Watts Bar Nuclear Plant, Unit 2
NRC Docket No. 50-391

**Subject: WATTS BAR NUCLEAR PLANT (WBN) UNIT 2 – REQUEST FOR
ADDITIONAL INFORMATION (RAI) REGARDING INDIVIDUAL PLANT
EXAMINATION (TAC NO. ME3334)**

Response to NRC Request for Additional Information Regarding IPE in June 23, 2010 Letter

Figure 3-1

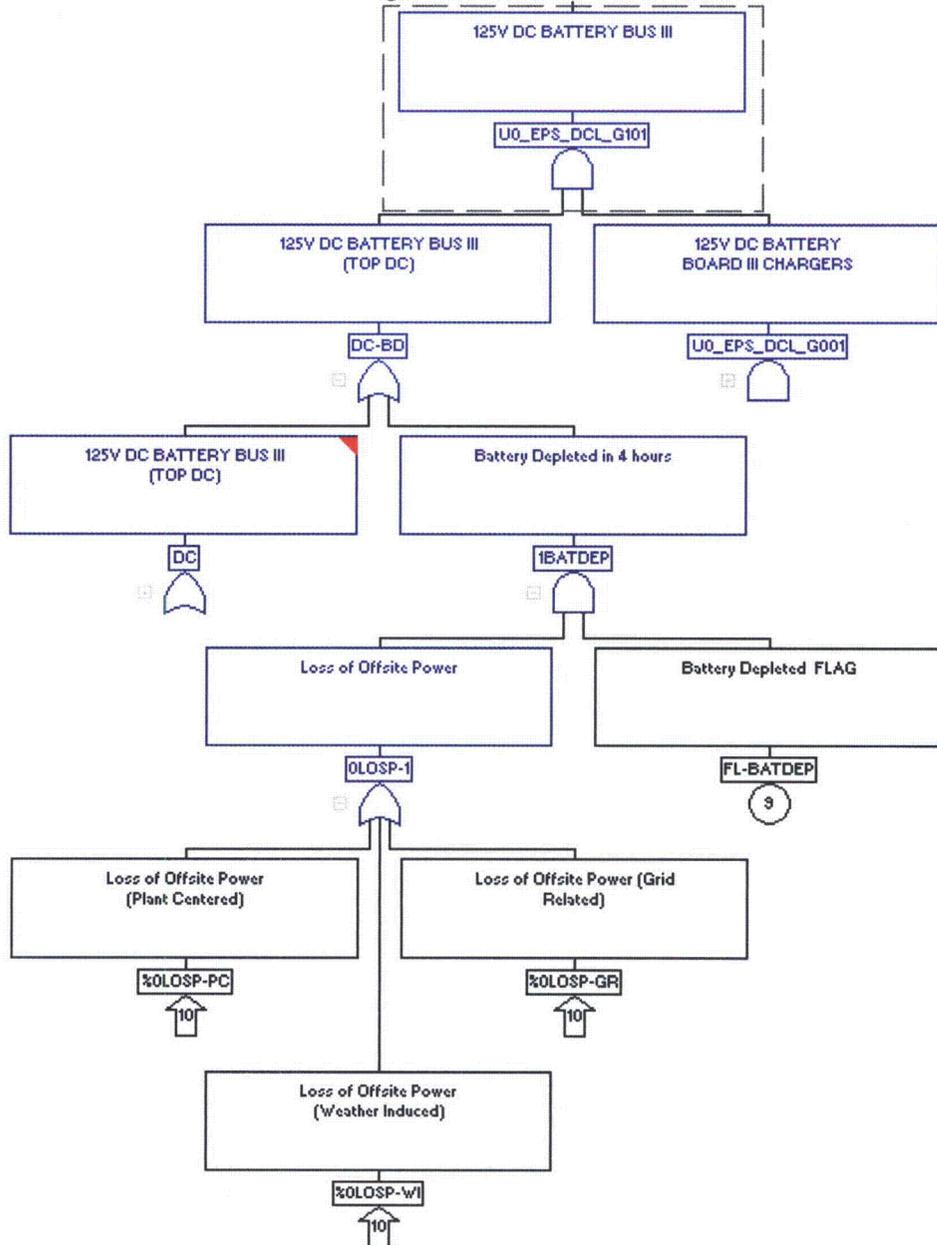
In the peer reviewed model, battery depletion was addressed in the model with an EQU gate containing all of Loss of Offsite Power (LOOP) IEs. The battery depletion gate is then applied into the model as a failure of the 125 Volt (V) DC vital battery boards. This logic incorrectly truncated the run failures of the Turbine-Driven (TD) Auxiliary Feedwater (AFW) pump and flow path.

Subsequent to the peer review, the battery depletion logic was revised and a basic event with a probability of 1.0 was ANDed with LOOP IEs under the battery depletion gate. Figure 3-1 displays the revised modeling for battery depletion. The revised model was requantified, and cutsets were reviewed to confirm that the delayed TD-AFW pump failures and battery failures were properly modeled.

To support the ongoing resolution of the second portion of this finding regarding the battery board dependencies, the 125V DC system models and loss of 125V DC battery board support system IE trees were reviewed. In the loss of battery board support system IE trees, the battery board failures are correctly modeled. Loss of a 125V DC board would result in loss of that train and results in an IE (e.g., BUSFR0BD_2361D_IE). After review of the 125V DC board system tops, it is recommended that the failure of battery board basic events (e.g., BUSFR0BD_2361-D) be moved above the battery board gate and battery charger

Figure 5-13: Unit 1 Flood-Initiator LERF Breakdown

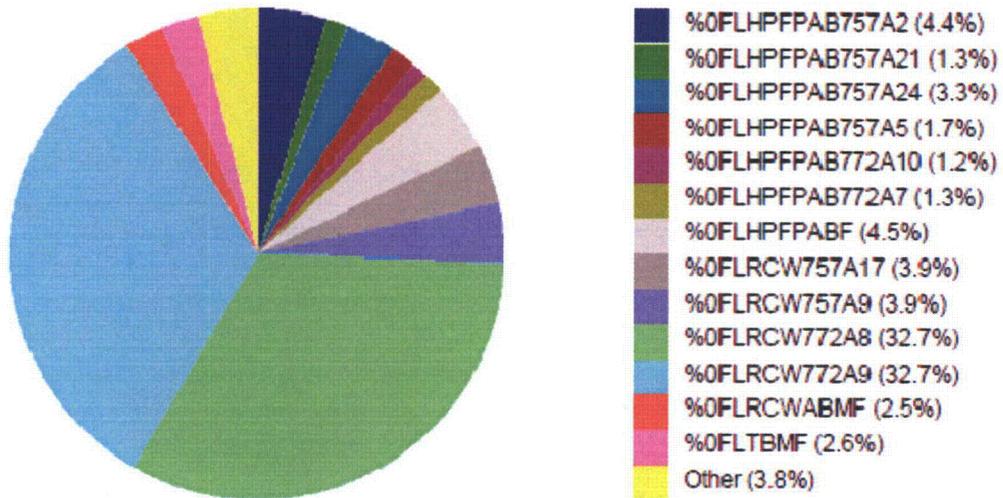
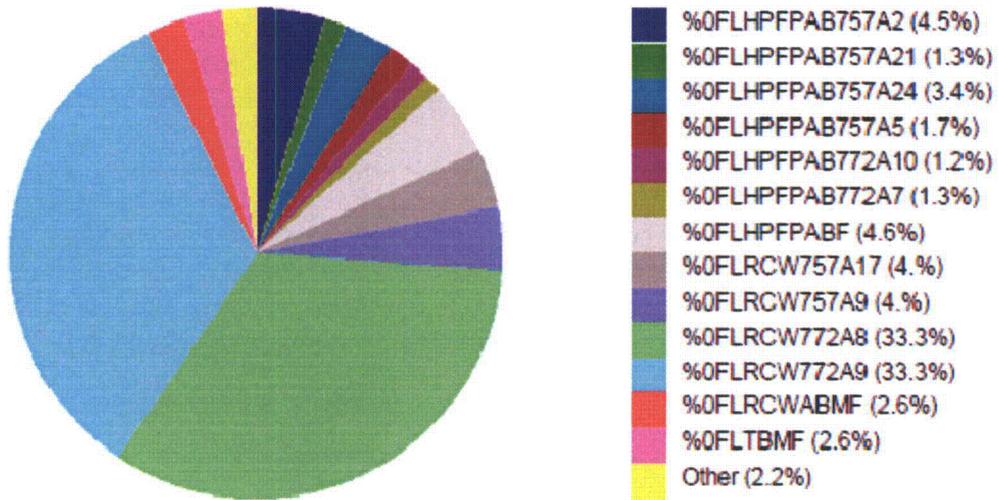
It is not clear how the peer review could indicate that SR IFQU-A10 was met when F&O 7-8 clearly states that the peer reviewer could find no evidence that the LERF analysis included internal floods. Further, in order to understand how and ensure that a more quantitative understanding of the overall probability of fission product releases was achieved, it is important that the PRA model addresses the potential contributors (e.g., internal flood). Provide a more complete description of how IF contributes to the LERF sequences (e.g., the development of event trees, event sequences, timing, etc.).

The concern in F&O 7-8 is the level of detail of the documentation regarding the impact of flooding scenarios on LERF. F&O 7-8 originated from SR IFQU-B1 because the issue was documentation rather than the technical methods used to link flooding events to the LERF model. As stated in the basis for assessment of SR IFQU-A10, “[t]he impact of flooding events on the LERF modeling is included by the linking model. However, no documented assessment of the flooding scenarios and how they map to LERF is provided.” Therefore, it was the assessment of the peer review team based on a review of the model that the impact of flooding on the LERF sequences was appropriately accounted for in the linked fault tree structure and IFQU-A10 was met. However, the level of documentation was insufficient to support model maintenance and peer review, and therefore SR IFQU-B1 was not met.

The IF impact is essentially superimposed on the base-line (i.e., no flood) PRA model and relies on the event trees and associated sequences already developed for the no-flood PRA base-line model. Flood-specific results are provided for both units. These results included both CDF and LERF. Major contributors to the flood only portion of CDF and LERF for both units are provided at the end of this response for the aforementioned table and the Figures 5-13 and 5-15 associated with LERF results. Because of the way the WBN IF-PRA is modeled, a specific flooding event tree is not used; a utility code injects flood-specific IEs and associated logic directly within the one-top linked fault tree model. WBN IF-PRA defines each flood scenario analyzed by defining the direct impact and the set of indirect impacts (more details on the indirect impacts, such as the specific failed components). The flooding logic was mapped to existing initiators that follow the general transient event tree. Specific sequences were then dictated by the specific direct and indirect failures and evolved into common plant damage states that were binned accordingly with the methodology and the criteria specified in the WBN PRA Level 2. IF initiators (i.e., GTRAN initiators) were binned either in Bin 1 or Bin 2. The modeling structure takes into account that some accident sequences may be common to both bins; these events are grouped with the most conservative bin via the model structure. The LERF values were based on the model containing IF. Specific event sequences (i.e., CDF cut sets) were discussed in the WBN PRA Quantification notebook and were not replicated in the IF-PRA notebook.
